**SUBDIVISION &
PLANNED UNIT DEVELOPMENT
STAFF REPORT**

Date: October 6, 2022

<u>DEVELOPMENT NAME</u>	Zeigler Boulevard Apartments
<u>SUBDIVISION NAME</u>	Zeigler Boulevard Apartments Subdivision
<u>LOCATION</u>	South side of Zeigler Boulevard, 390'± West of Cody Road, extending to the West side of Cody Road, 575'± South of Zeigler Boulevard.
<u>CITY COUNCIL DISTRICT</u>	District 7
<u>AREA OF PROPERTY</u>	3 Lots / 32.0± Acres
<u>CONTEMPLATED USE</u>	Subdivision approval to create three (3) legal lots of record from a single metes-and-bounds parcel; and Planned Unit Development approval to allow multiple buildings on a single building site.
<u>TIME SCHEDULE FOR DEVELOPMENT</u>	Construction begin Fall 2023

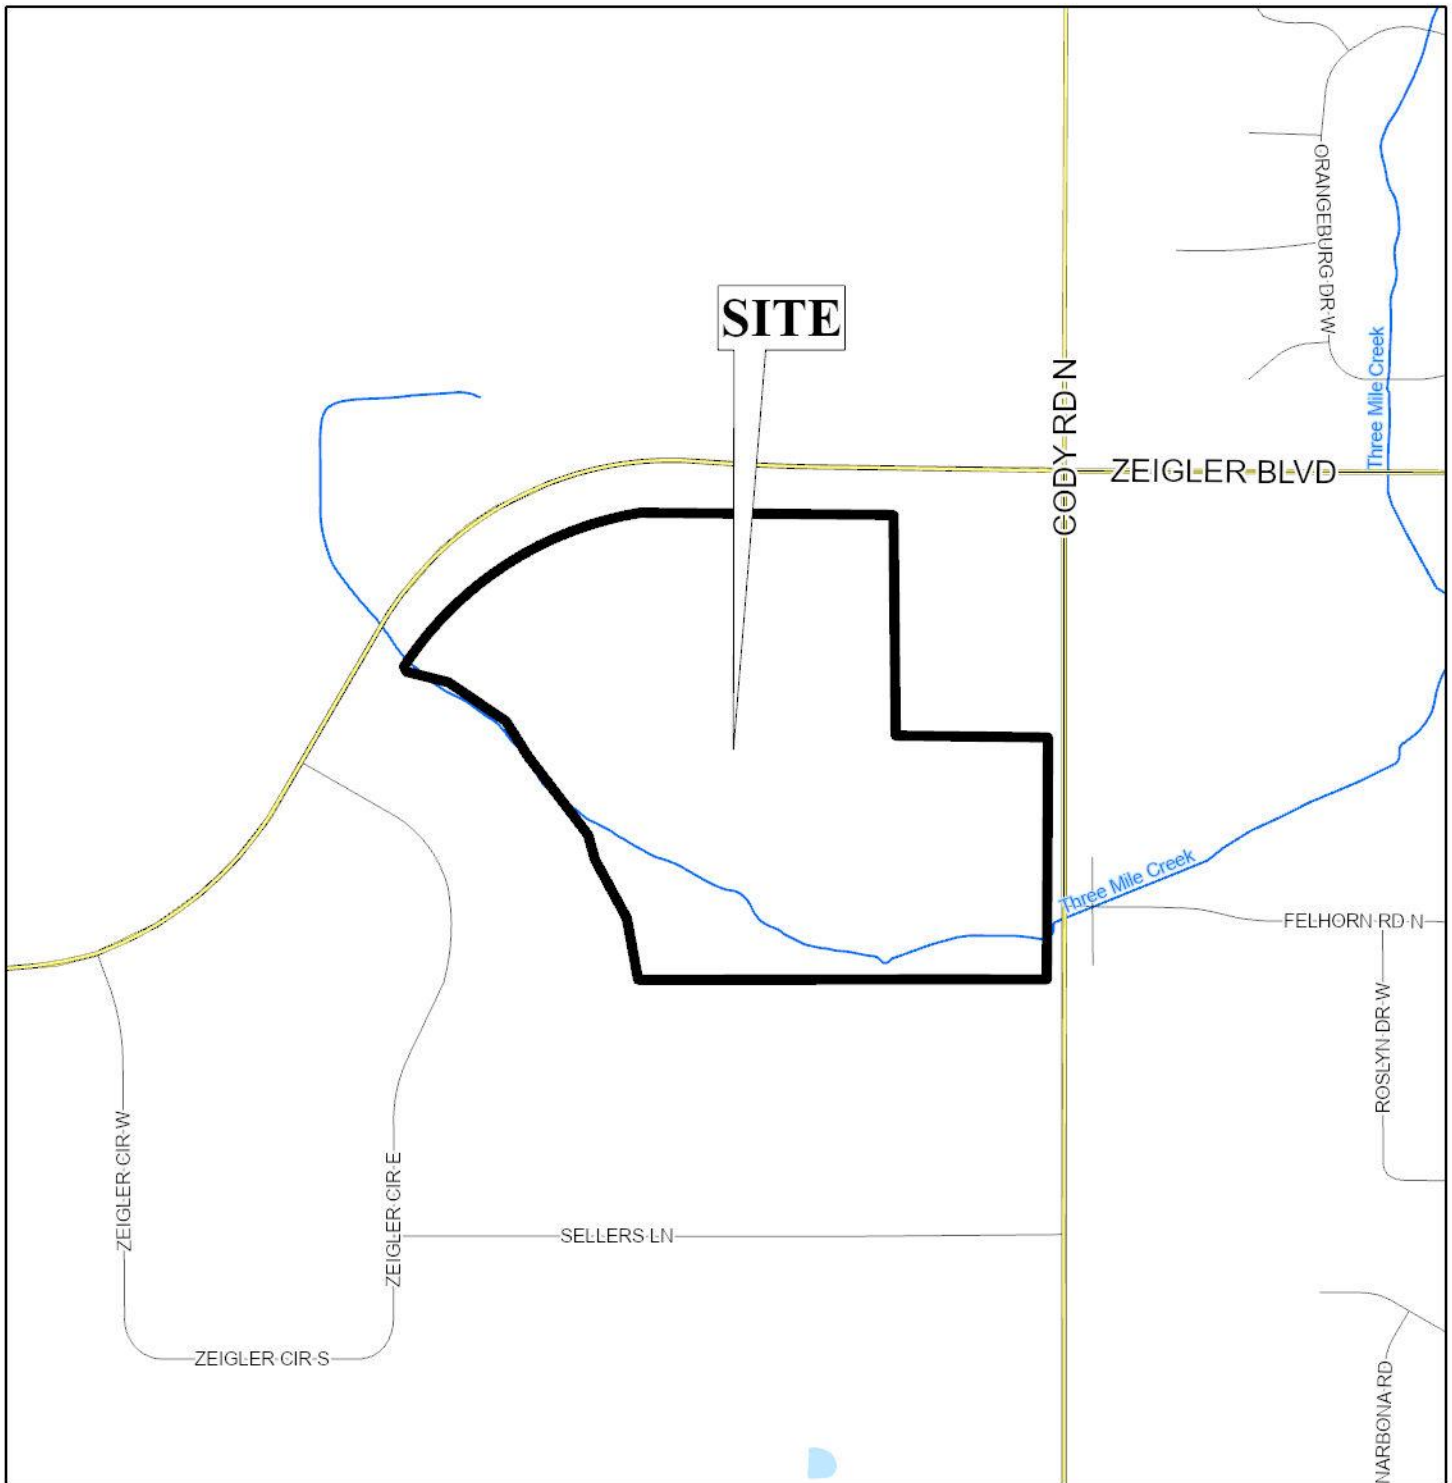
The applicant is proposing a three-phase apartment complex, but a detailed site plan was not submitted, rather a conceptual plan image was submitted.

The conceptual plan depicts a total of eighteen (18) structures with 318 dwelling units for the entire development, two (2) maintenance sheds (960 square feet), a clubhouse/leasing office (5,890 square feet), a pool, a BBQ pavilion, and a dog park. The applicant has the following table in their narrative regarding the number of dwelling units:

As the narrative and the site plan do not agree on the number of dwelling units proposed for the overall site, it is difficult for staff to conduct a thorough review.

Furthermore, the conceptual plan submitted does not depict individual parking spaces, making it difficult for staff to determine how many parking spaces are proposed. Based on the proposed sizes for the office and maintenance sheds, 23 parking spaces are required, and depending on the number of dwelling units proposed, either 477 parking spaces or 1,161 parking spaces will be required. Regarding traffic circulation and parking on site, the applicant states:

Based on this, the applicant is proposing a deficit of 21 parking spaces for 774 units, and is not considering the 23 parking spaces required for non-dwelling uses on the property, resulting in an overall possible shortage of 44 parking spaces for the development. As the development will be required to have more than 25 parking spaces, a compliant photometric site plan will be required at the time of permitting, if approved.

The conceptual plan submitted does not depict a dumpster, therefore if approved, the site plan should be revised to depict a dumpster on site, with a compliant enclosure and sanitary sewer connection.

As this will be the first development of the site, full compliance with tree plantings and landscape area will be required. The conceptual plan submitted depicts several trees as “potential preservation”, but does not provide the size or species of the trees, and it is difficult to tell if the trees will have sufficient room to continue to thrive. The narrative includes information regarding the standard Zoning Ordinance requirements, but only provides the amount of landscaped area in acres. If approved, a site plan should be submitted depicting the amount of landscaped area in square feet, rather than acres, and include a note stating that the site will comply with tree planting requirements, and will coordinate with staff at the time of permitting.

It is recommended that the applicant submit a site plan addressing the inconsistencies with the conceptual plan and the narrative, so that staff can conduct a more complete review, and insure the development will comply with the Zoning Ordinance.

Planned Unit Development: The application is recommended for Holdover to the November 3rd meeting, with revisions due no later than October 14th to address the following items:

- 1) Submittal of a site plan depicting the number of dwelling units proposed for the development;
- 2) Submittal of a site plan illustrating the number of parking spaces proposed for the development, including a table with the associated parking calculations;
- 3) Placement of a note on the site plan providing the amount of total and front landscaped area in square feet proposed for the development;
- 4) Submittal of a site plan depicting existing trees to be preserved, labeled with their size and species;
- 5) Submittal of a site plan depicting any proposed dumpsters or trash compactors, with compliant enclosures and sanitary sewer connections; and
- 6) Submittal of a site plan depicting sidewalks along Zeigler Boulevard and Cody Road North.
